COMMUNITY BOARD FEEDBACK PACKAGE

DINING OUT NYC

Business Name: The Mercury

Cafe Address: 659 9 AVENUE, NEW YORK, NY, 10036

Sidewalk Cafe Site Plan Form

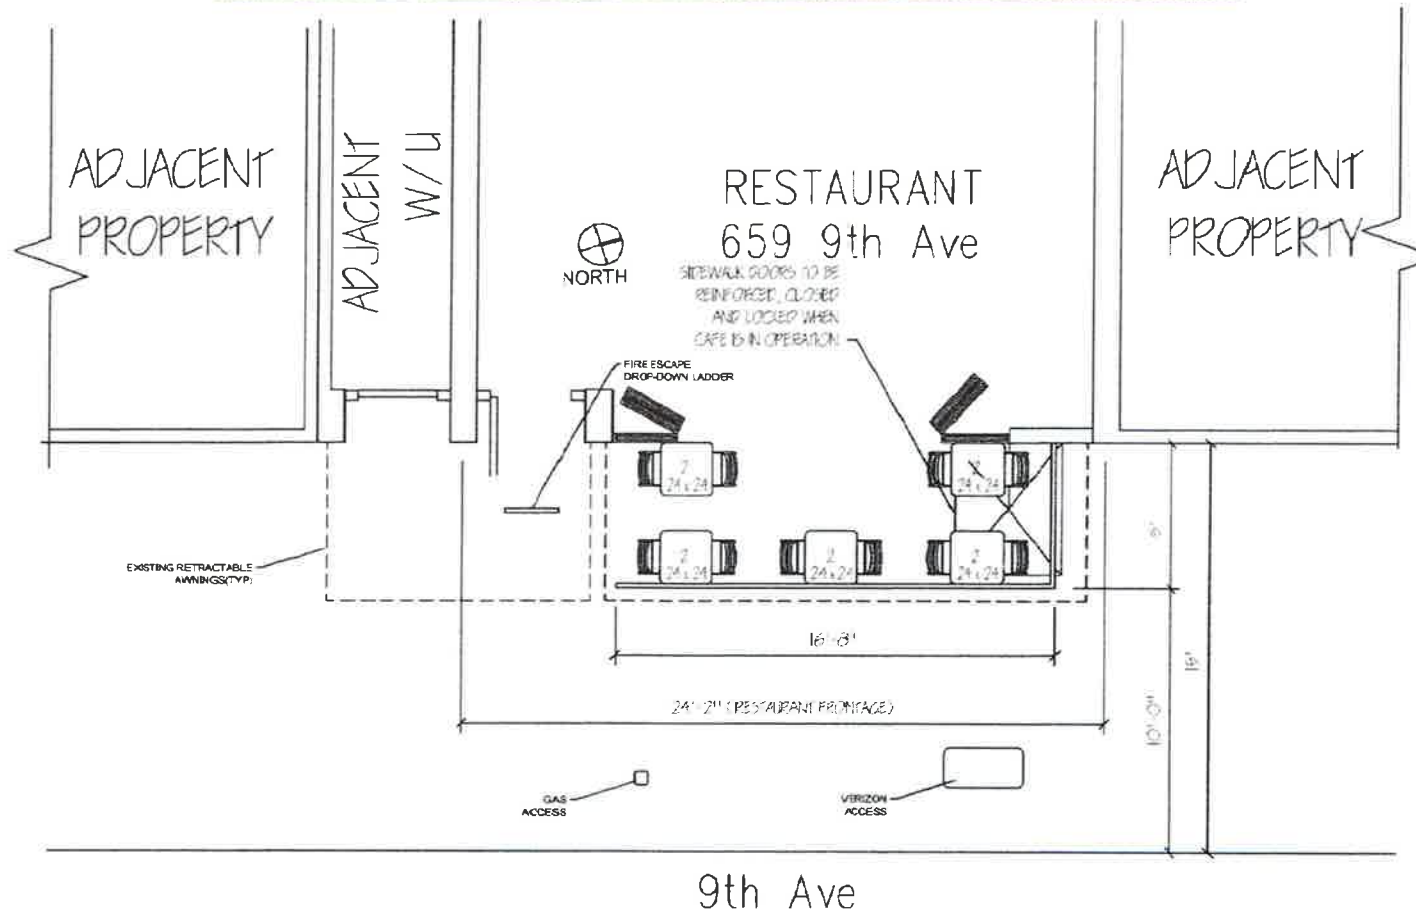
The awning above the sidewalk cafe at this location appears to block the building's fire escape from descending to sidewalk level.

Although MCB4 recommends approval of this sidewalk cafe, that approval is contingent on the applicant's altering or removing the awning beneath the building's fire escape so that the fire escape can properly descend to sidewalk level if necessary.
